National Committee on Uniform Traffic Control Devices

National Committee on Uniform Traffic Control Devices (NCUTCD) Recommended Changes to Proposed Text for 11th Edition of the MUTCD Docket Number: FHWA-2020-0001

7 **NPA MUTCD Section Number:** 2J

Figure 2J-1. Examples of Specific Service Signs

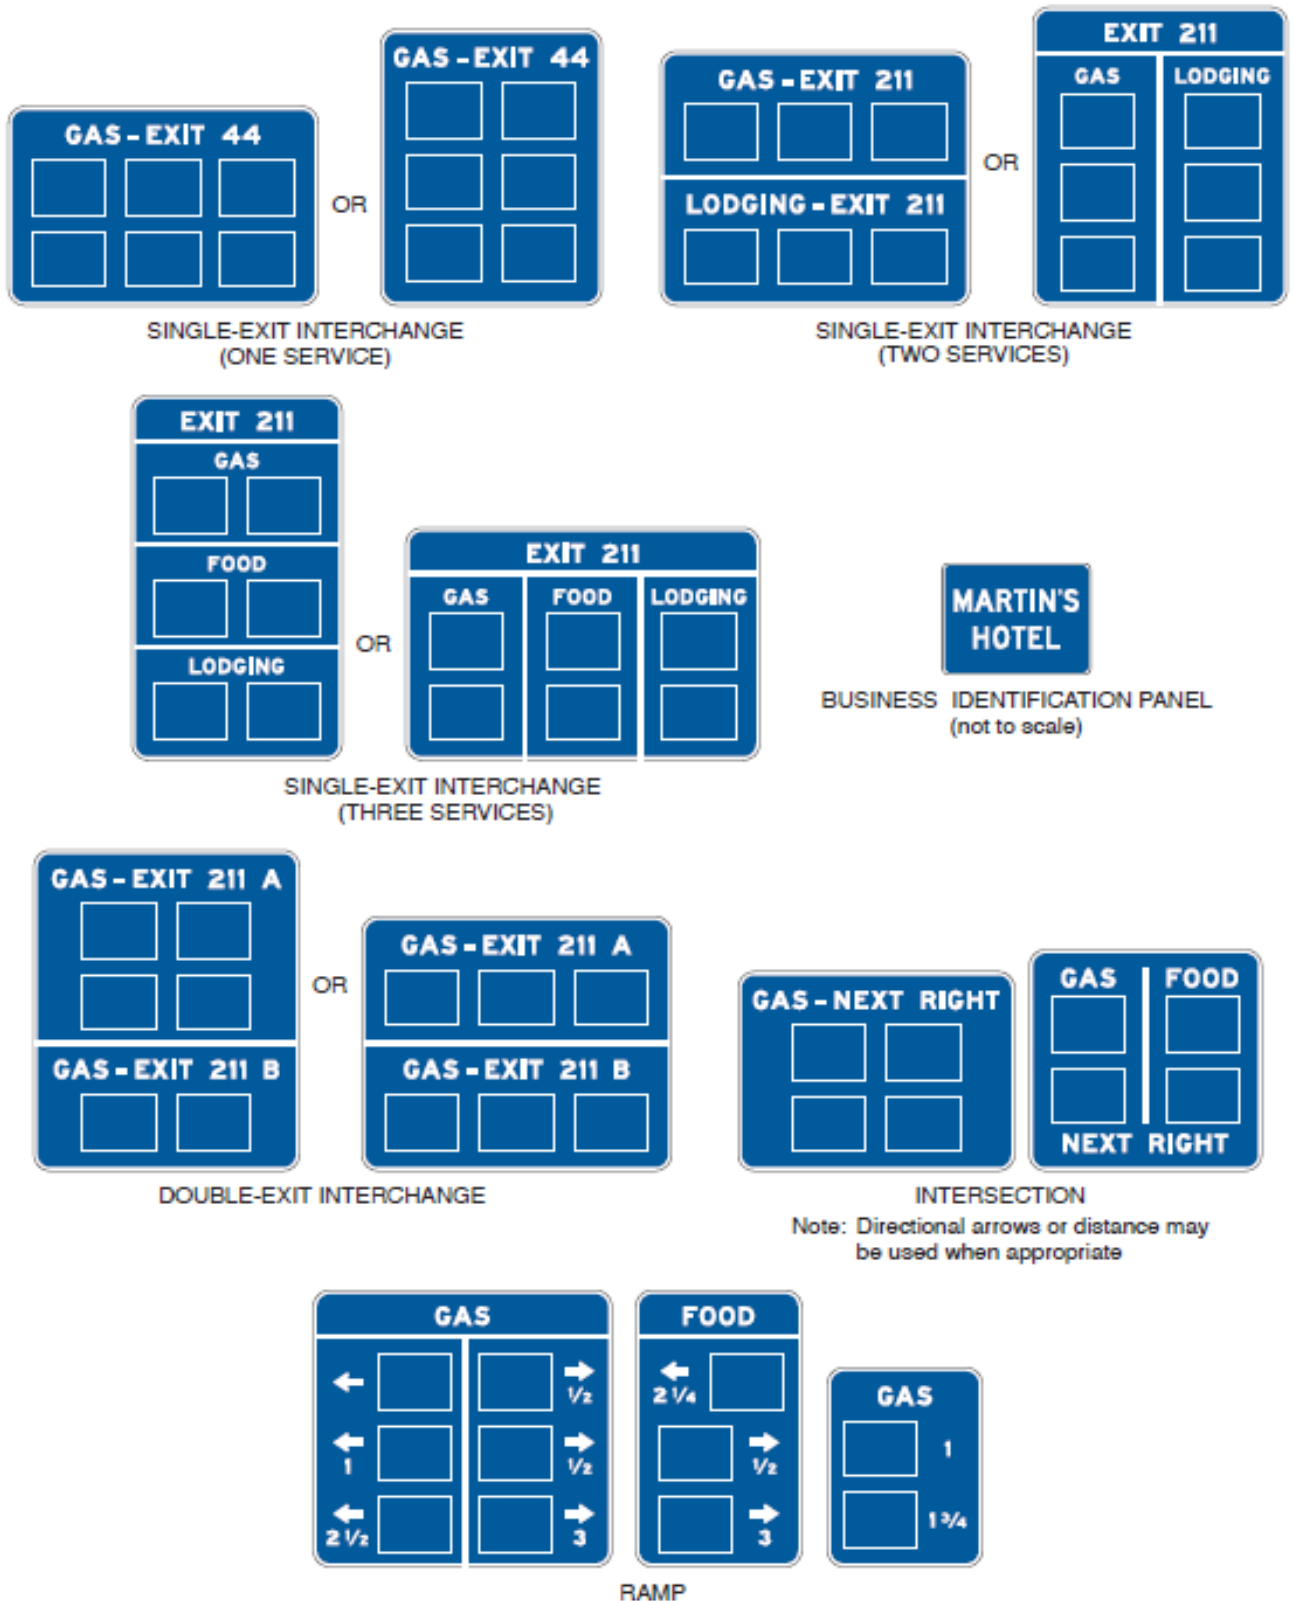
NCUTCD agrees with Figure 2J-1 as shown in the NPA.

Figure 2J-2. Examples of Specific Service Sign Locations

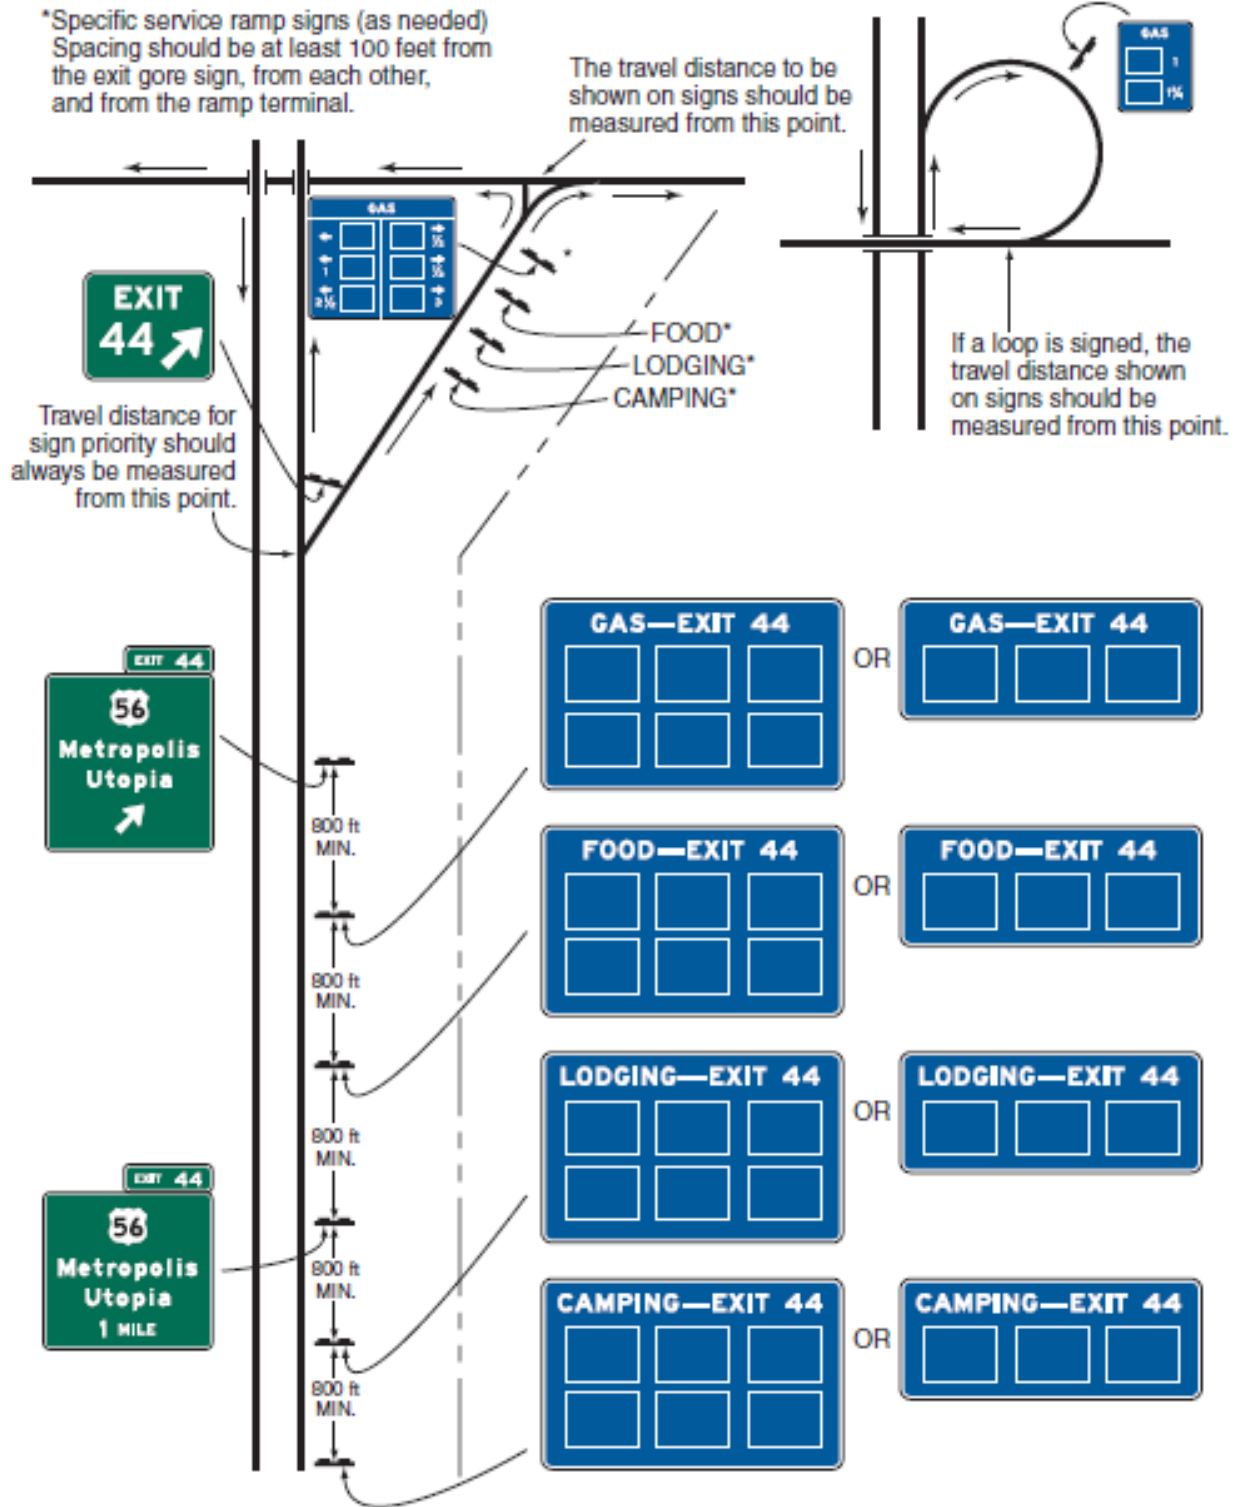
NCUTCD agrees with Figure 2J-2 as shown in the NPA.

Figure 2J-4. Signing for Services Accessed from Collector-Distributor Road Adjacent to Freeway

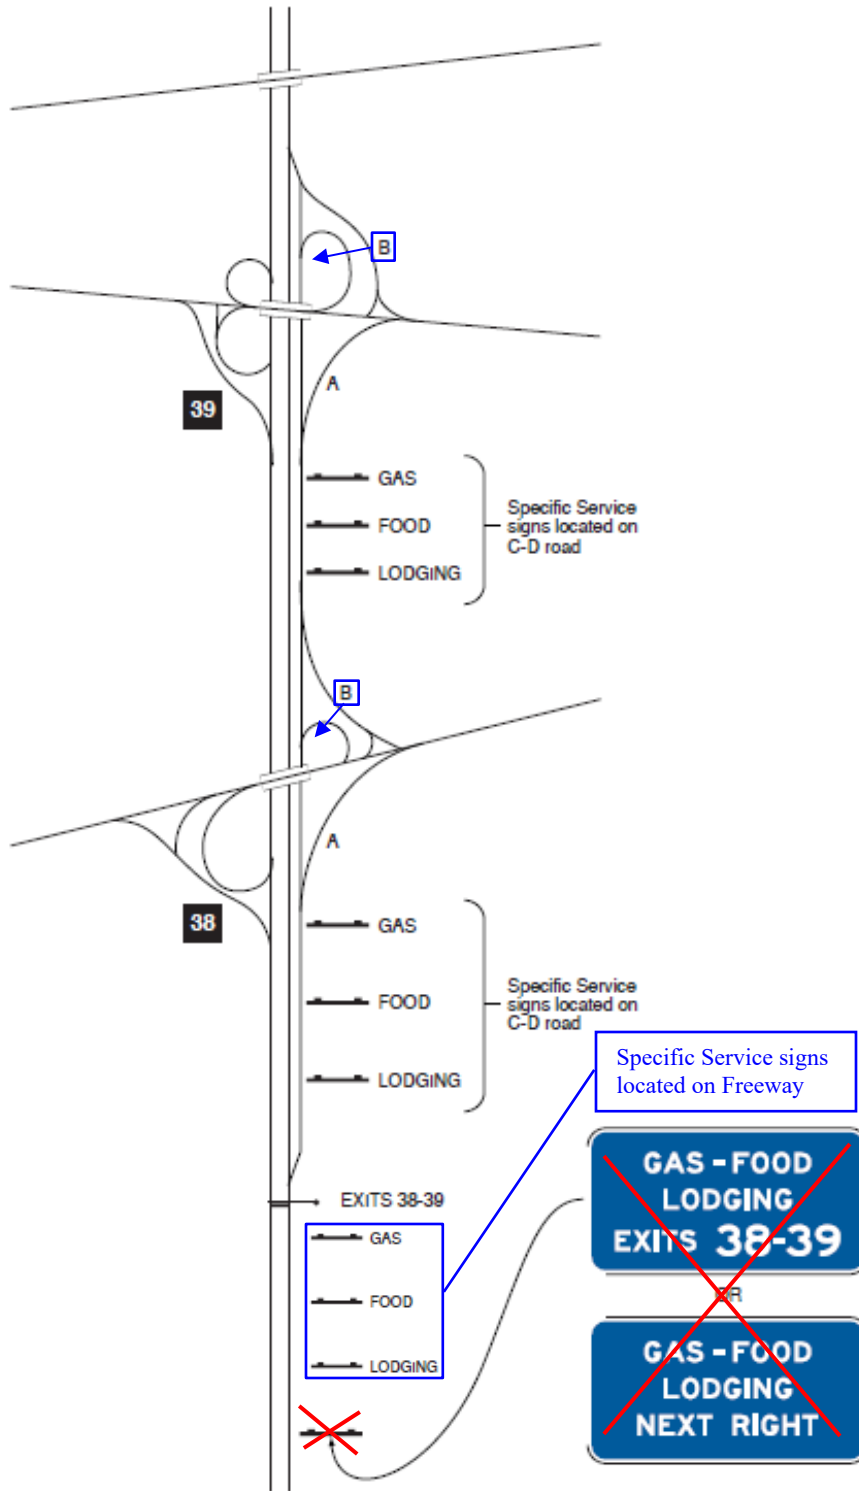
444 **Section 2J.09 Comments:** NCUTCD recommends revising 2J.09 and Figure 2J-4 to replace the
445 use of General Service signs along the main roadway with Specific Service signs and to add a
446 standard that Specific Service signs along the collector-distributor cannot be displayed unless
447 also displayed along the main roadway.

478
 479 NCUTCD recommends revising Figure 2J-4 to relocate the designation of Exit “B” to denote the
 480 exit location more accurately and to replace the General Service signs along the main roadway
 481 with Specific Service signs.

Figure 2J-5. Examples of Specific Service Trailblazer Signs

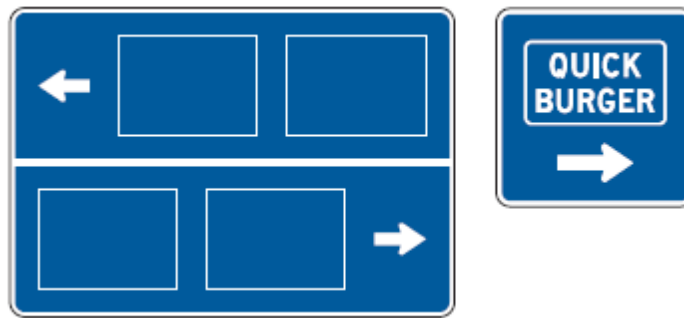
NCUTCD agrees with Figure 2J-5 as shown in the NPA.
